DOCUMENT 00 90 00
ADDENDUM

ADDENDUM No.: 1

RE: LOGAN HS HVAC UPGRADES
SCHOOL DISTRICT OF LA CROSSE
1500 RANGER DRIVE
LA CROSSE, WI 54603
PROJECT NO. 22057

M002

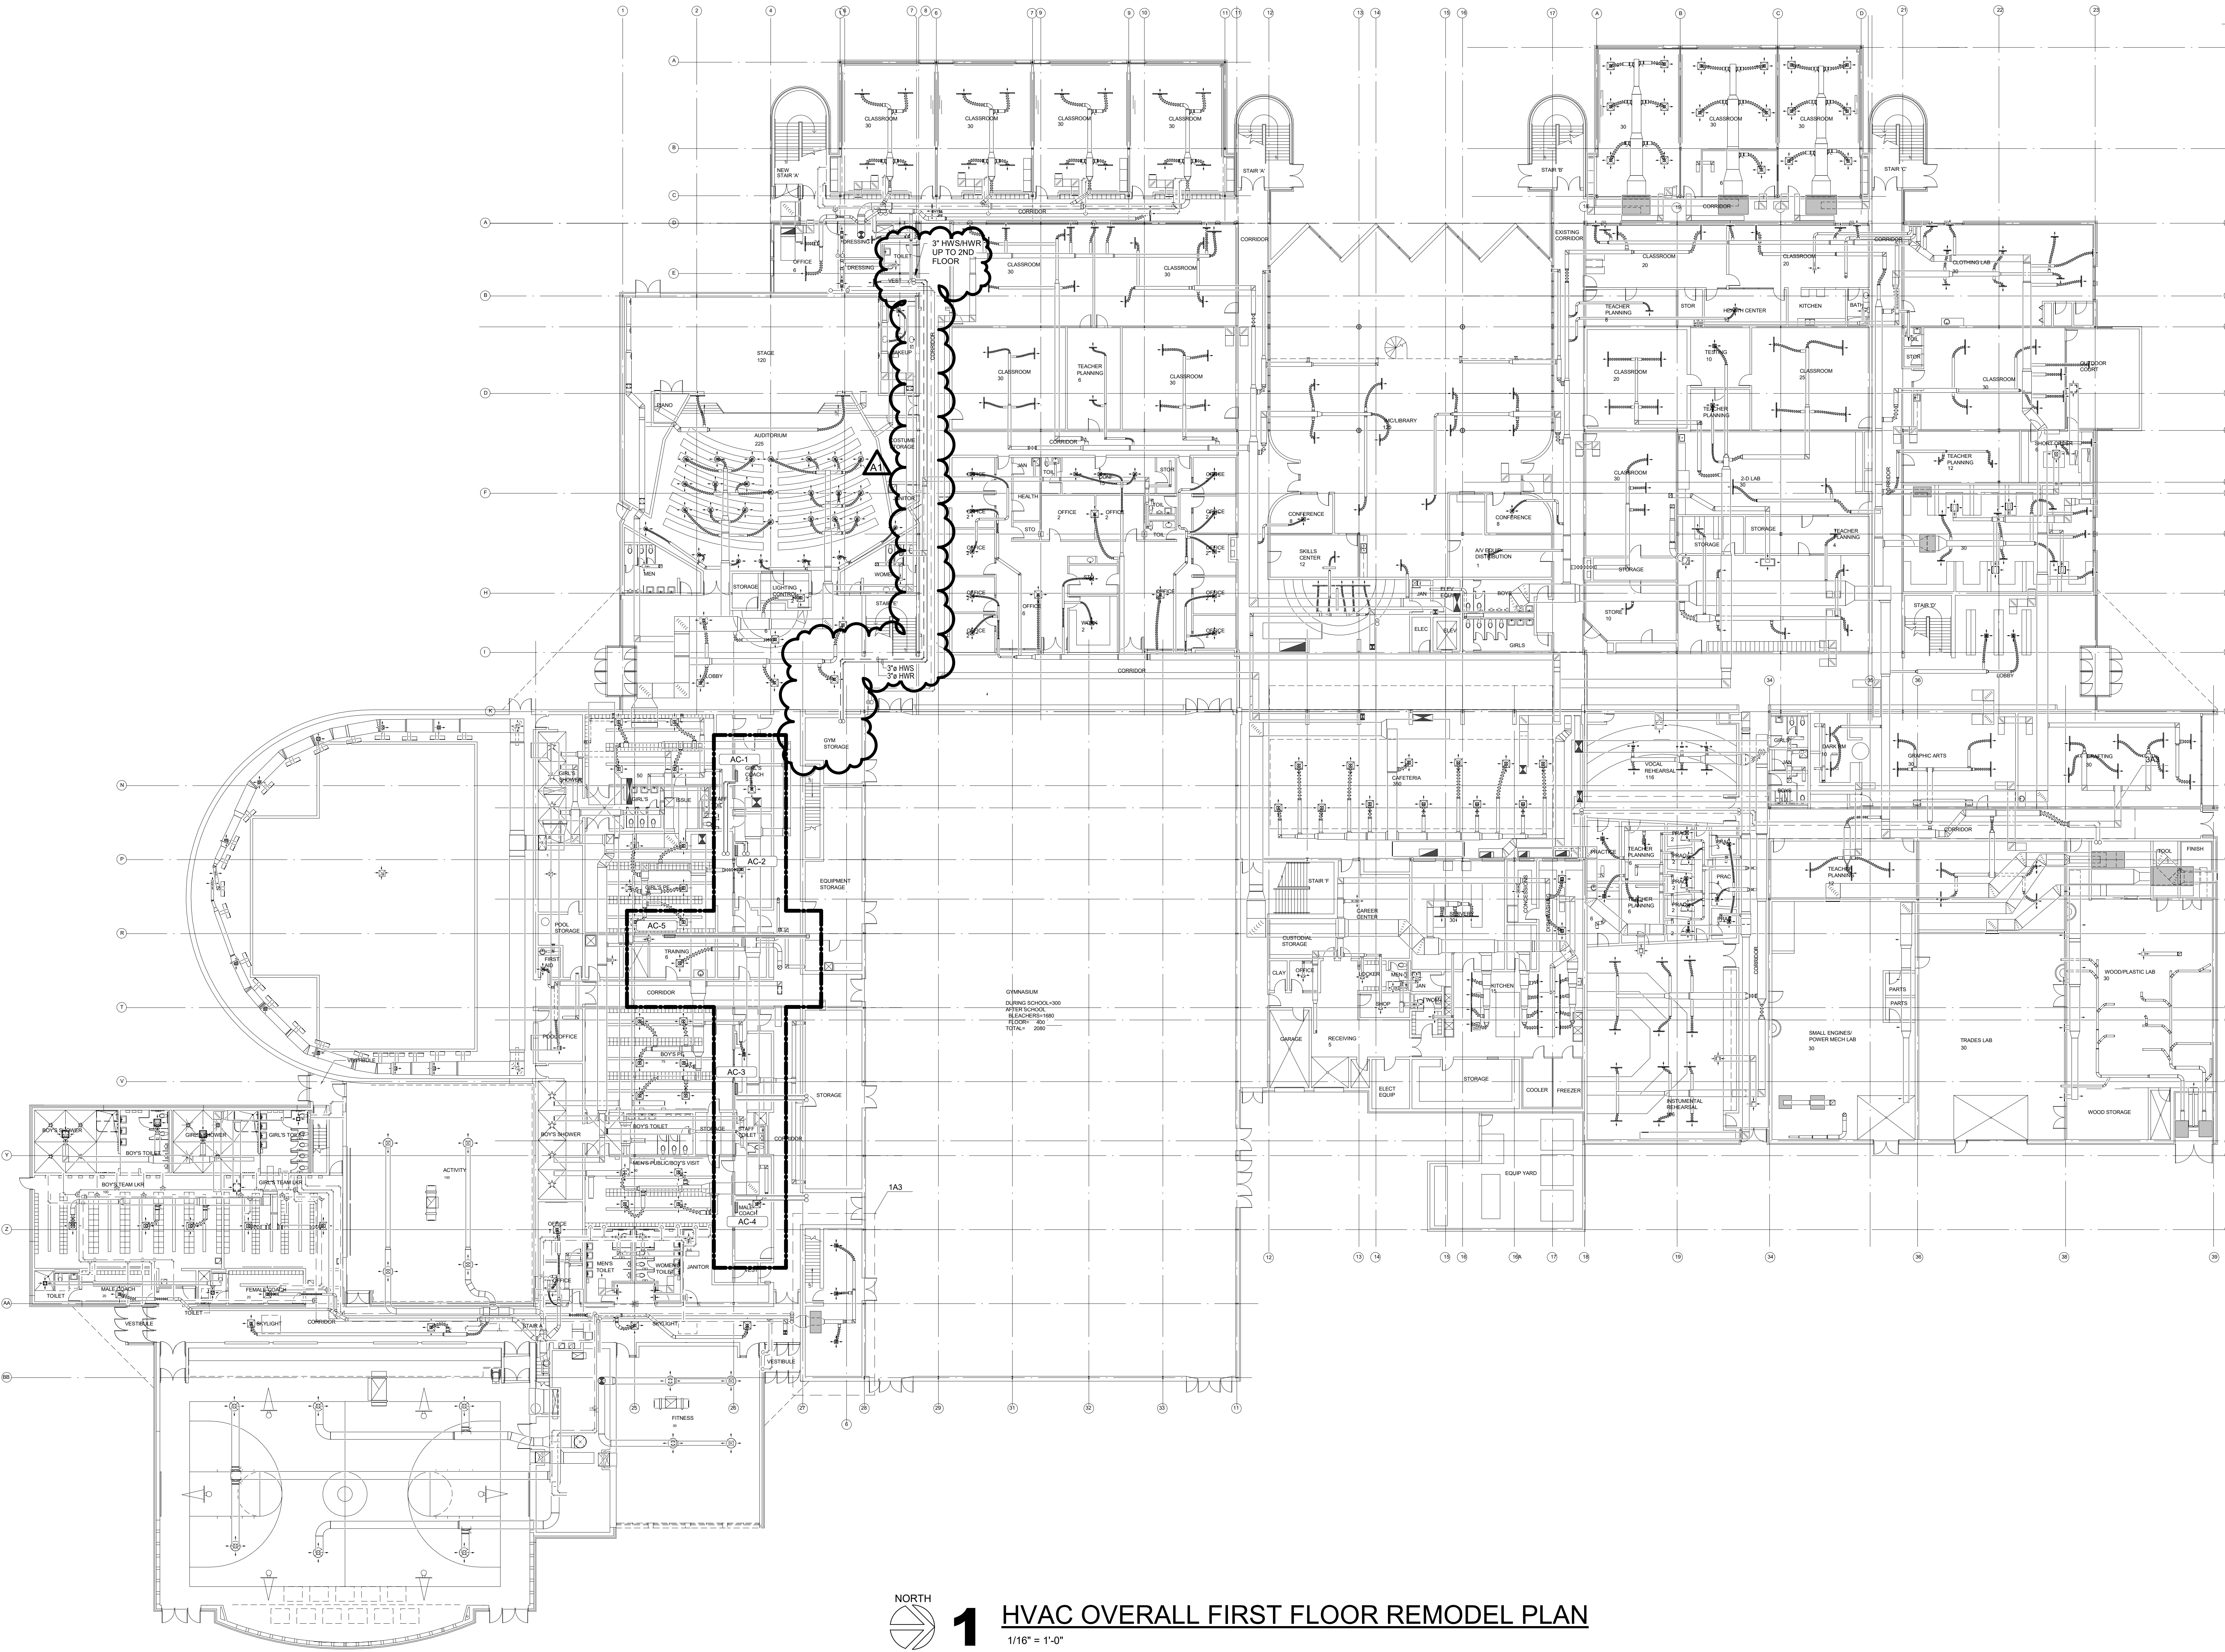
3. Sheet M002 HVAC OVERALL FIRST FLOOR REMODEL PLAN 30"x42"
 - a. See the revised sheet included in this addendum. Disregard the previous version.
 - b. Modified routing of new 3" HWS/HWR piping to first floor ceiling and follow the routing of existing chilled water piping.
4. Sheet M003 HVAC OVERALL SECOND FLOOR REMODEL PLAN 30"x42"
 - a. See the revised sheet included in this addendum. Disregard the previous version.
 - b. Modified routing of new 3" HWS/HWR piping to first floor ceiling and follow the routing of existing chilled water piping.

M201

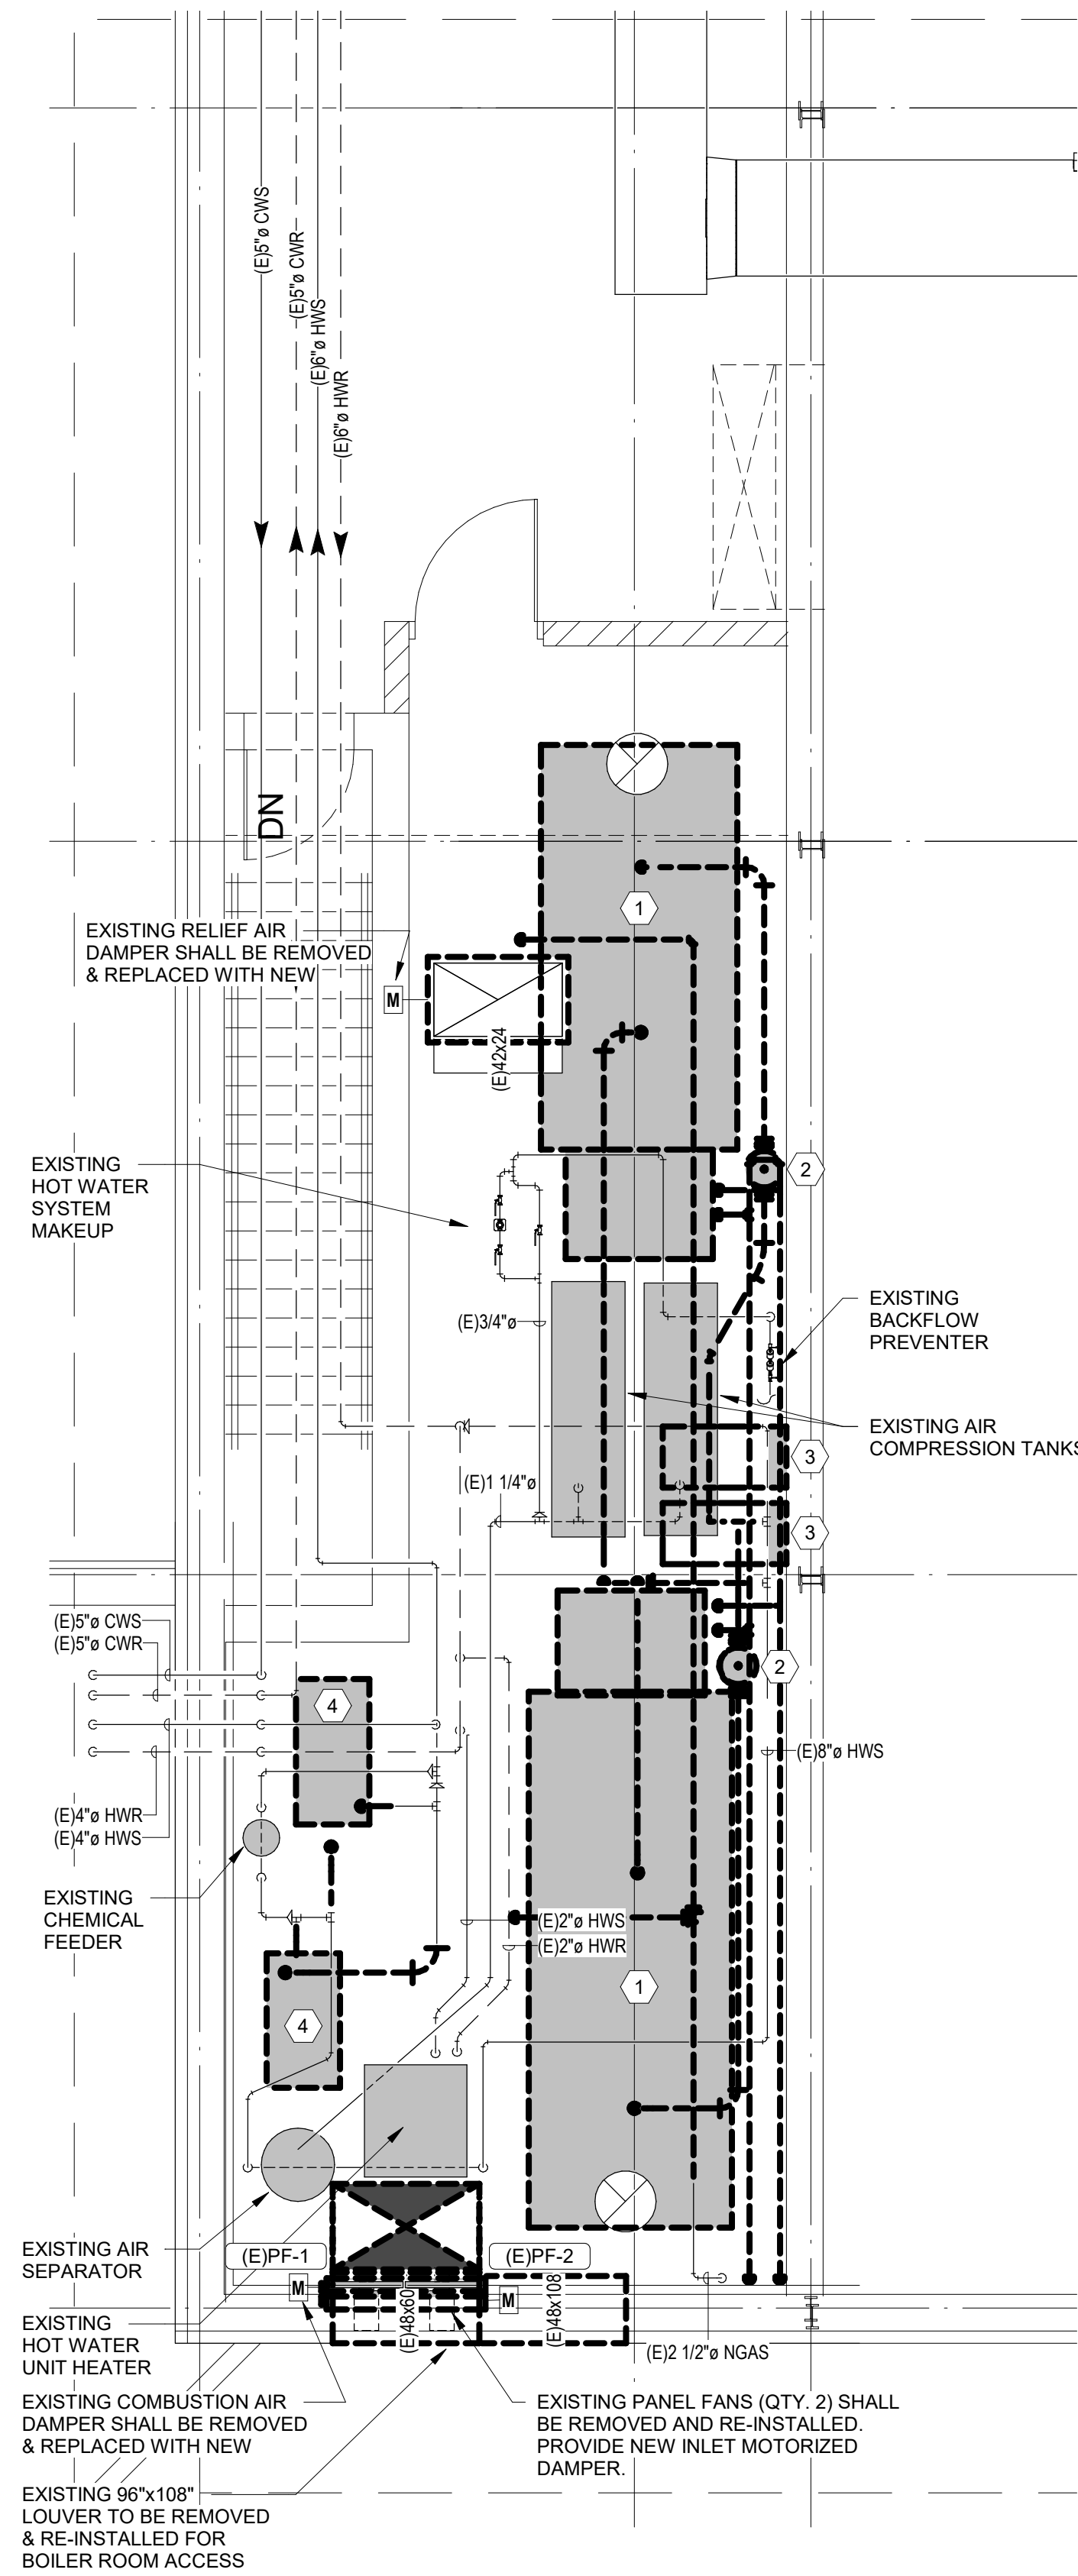
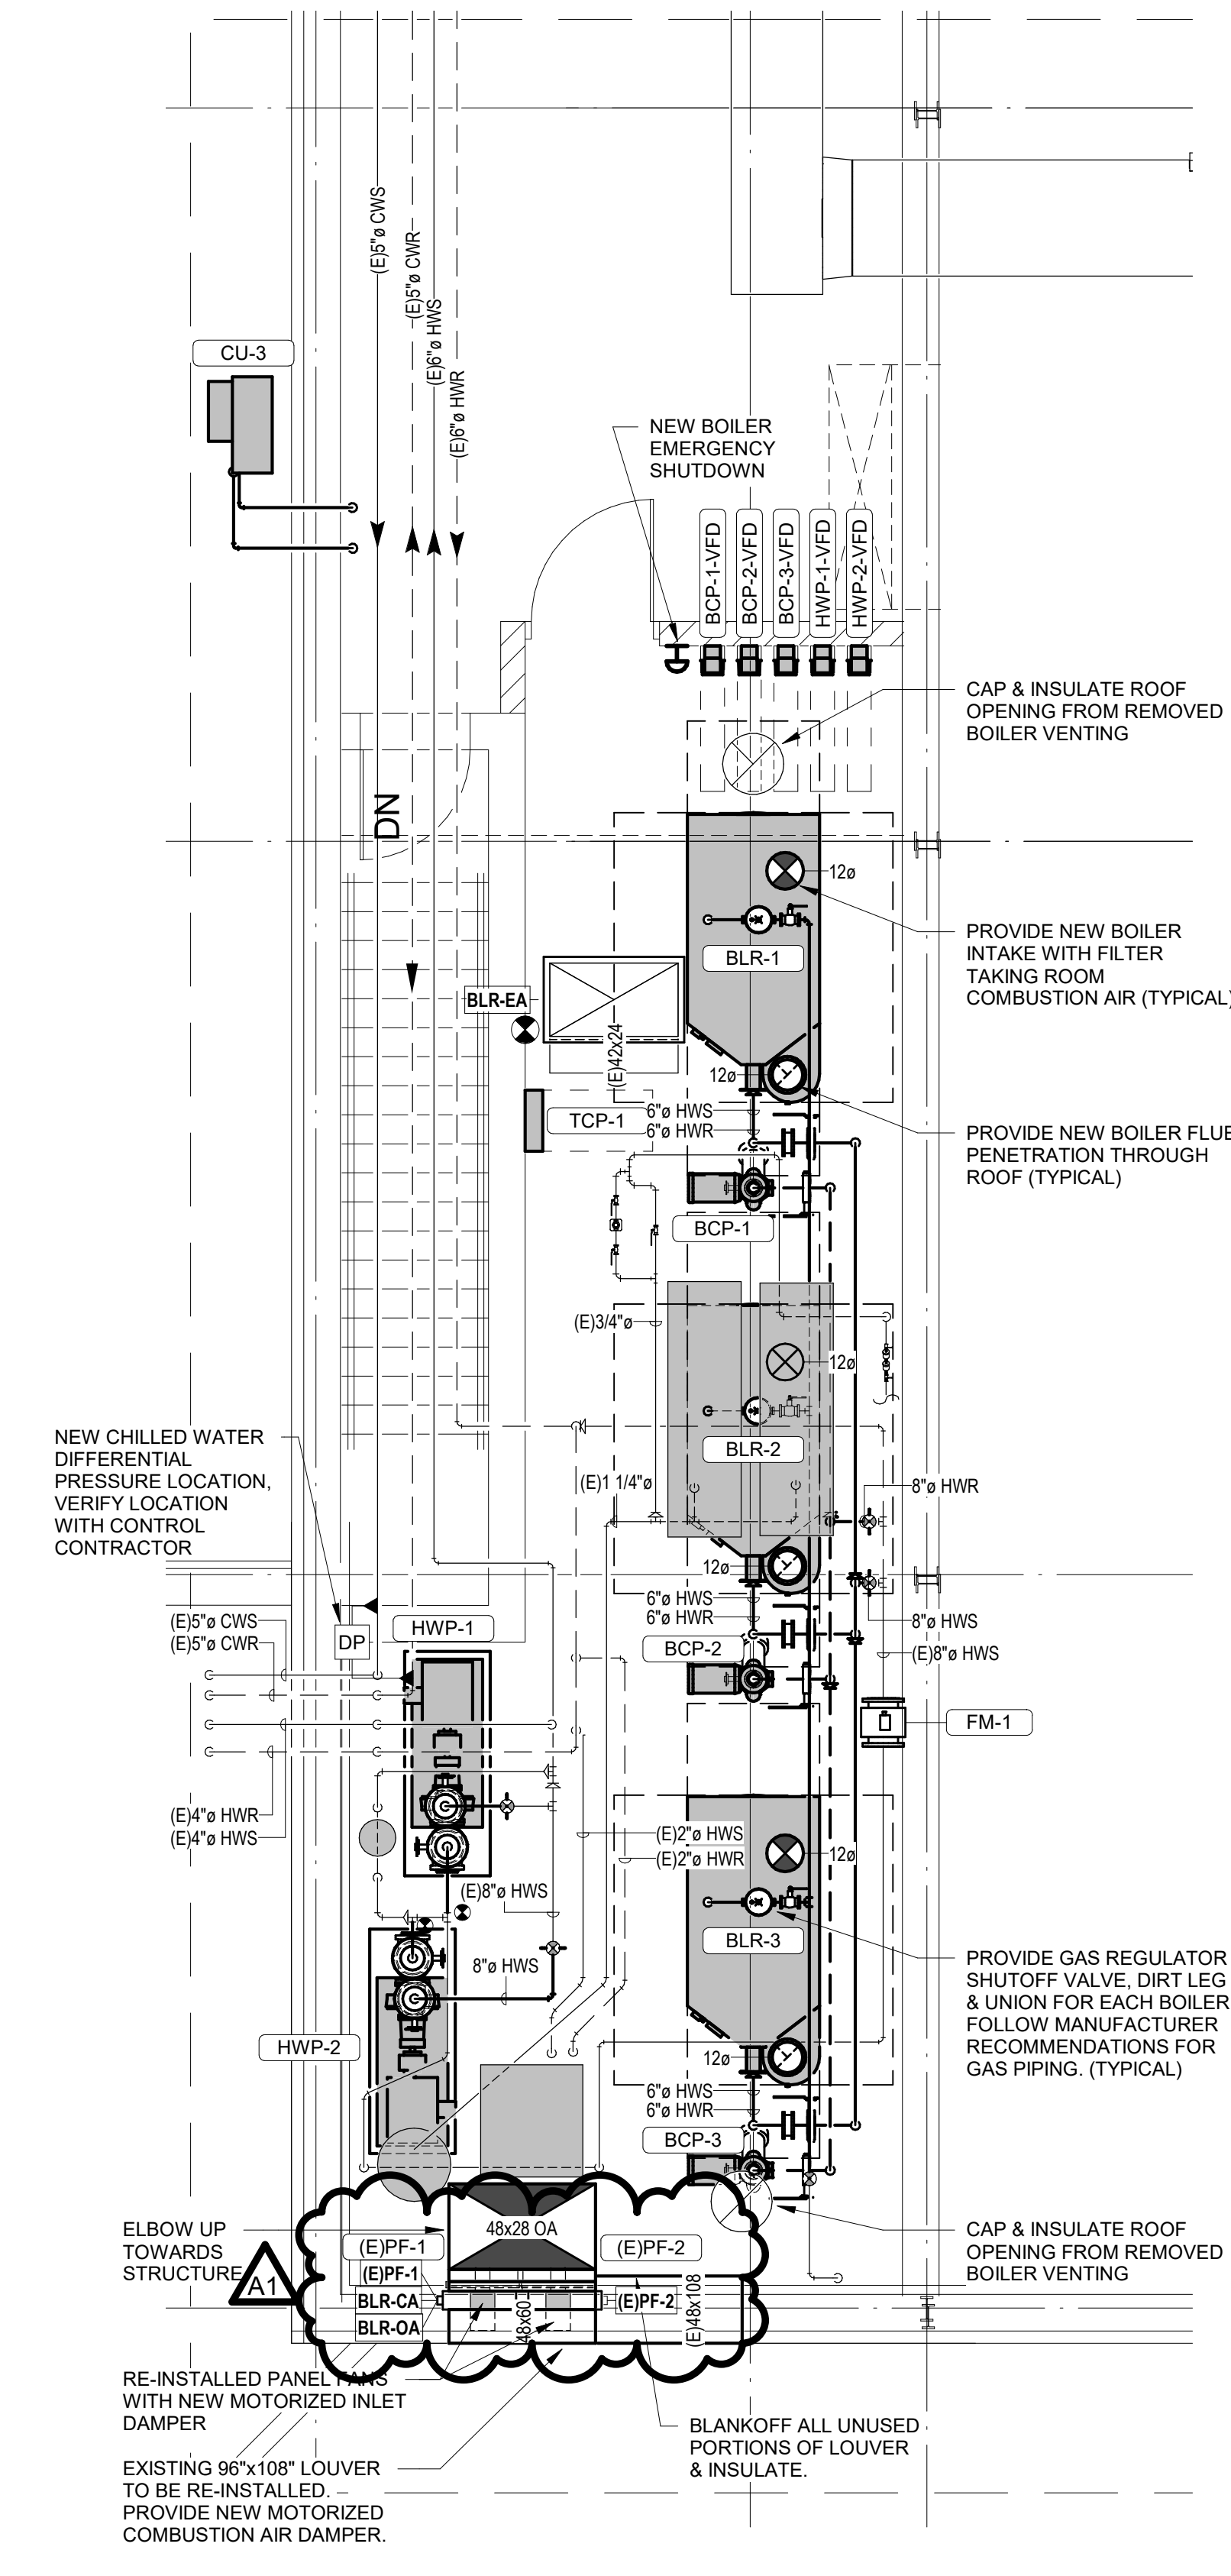
5. Sheet M201 ENLARGED PLANS 30"x42"
 - a. See the revised sheet included in this addendum. Disregard the previous version.
 - b. Added motorized dampers (E)PF-1 and (E)PF-2 to floor plan.
6. Sheet M202 ENLARGED PLANS 30"x42"
 - a. See the revised sheet included in this addendum. Disregard the previous version.
 - b. Modified routing of new 3" HWS/HWR piping to come through the floor of the 1995 Boiler Room.
7. Sheet M601 HVAC SCHEDULES 30"x42"
 - a. See the revised sheet included in this addendum. Disregard the previous version.
 - b. Added (E)PF-1 and (E)PF-2 to Motorized Damper Schedule.
8. Sheet E103 ELEC. REMOVAL AND REMODEL PLAN 30"x42"
 - a. See the revised sheet included in this addendum. Disregard the previous version.
 - b. Add motors HWP-1 and HWP-2 to Motor Schedule
 - c. Add Note #4 to motor schedule remarks.
 - d. Revised remarks column in motor schedule.
